NOTICE TO APPLICANTS ADDENDUM NO. ONE (1)

Ponce De Leon Springs State Park – Restroom Additions DEP BID NO. BDC20-23/24

ELECTRICAL SITE PLAN - LIFT STATIONS

E102

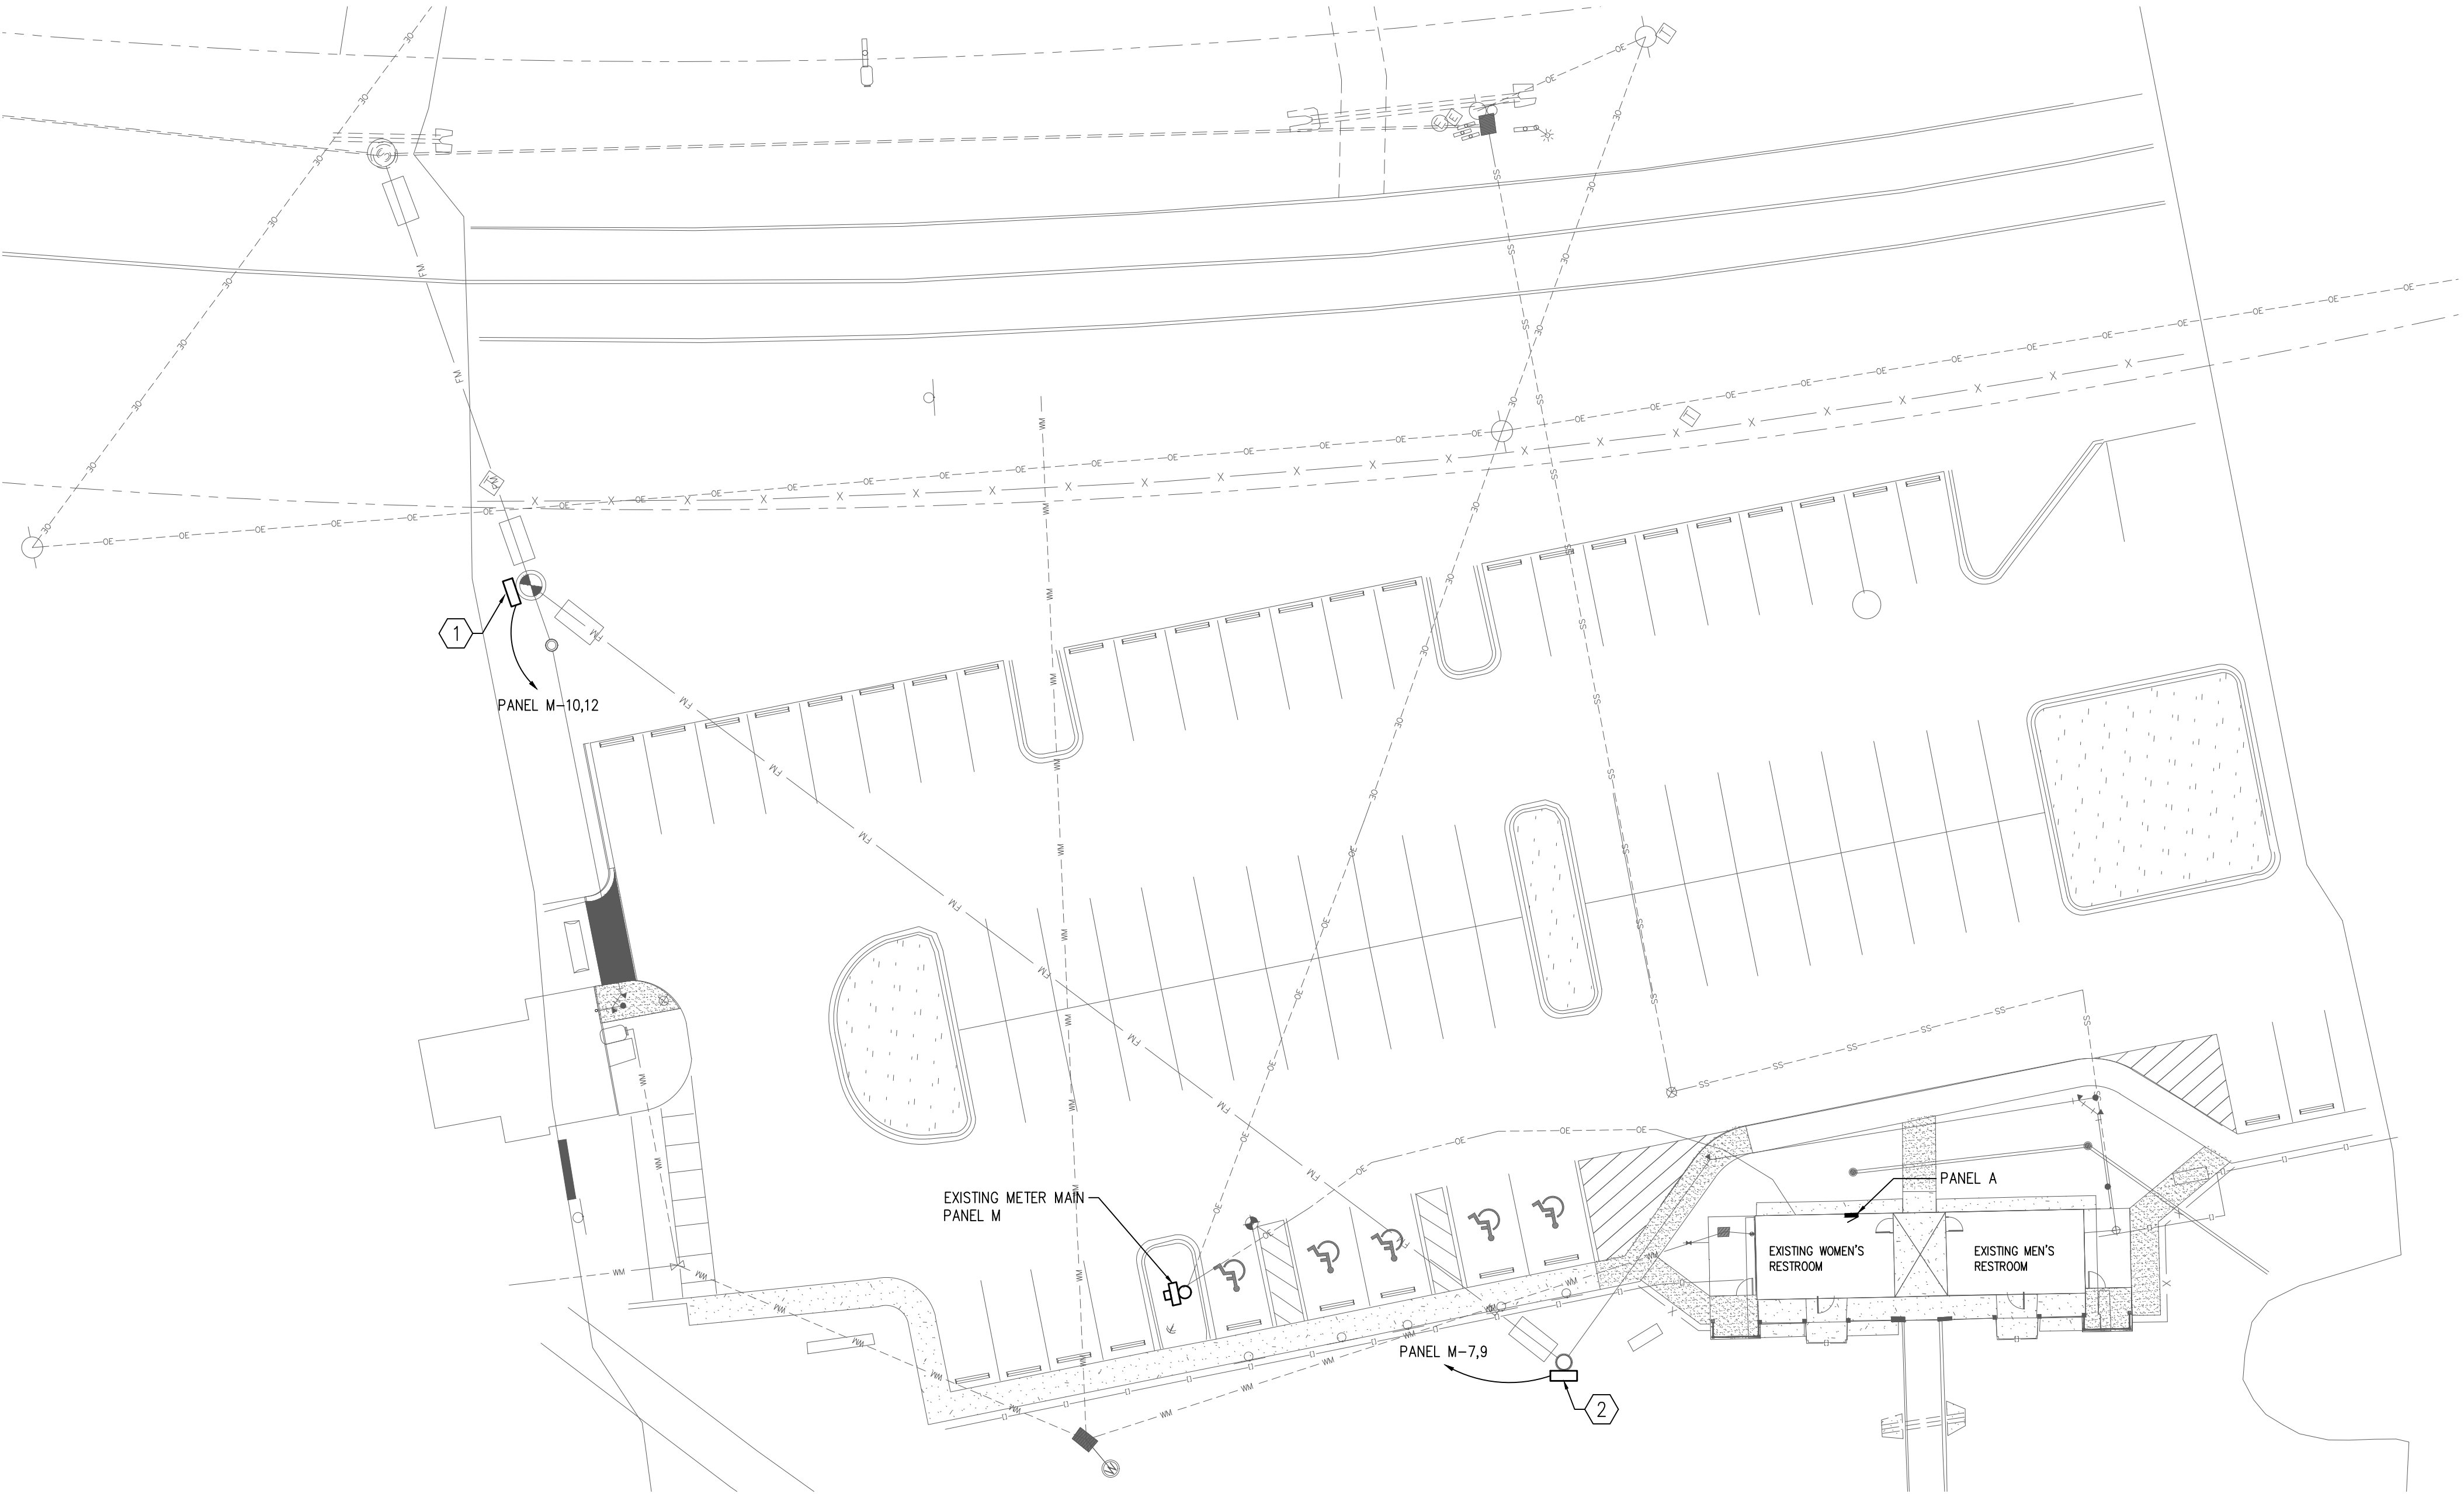
Answer: At this time, the exact material and gauge of the roof are not specified. Bidders should make that determination based on their site visits.
- 3. Question:** I do not see any electrical plans for the lift stations. The cover sheet says there is a sheet E102, but it is missing from the plans.

Answer: Electrical information pertaining to the lift stations is shown on E102. This sheet has been attached to this response.
- 4. Question:** Are you aware that the 2 exterior Cline Doors specified have 18-week lead times after approval, and it's possible they will hold up the entire job?
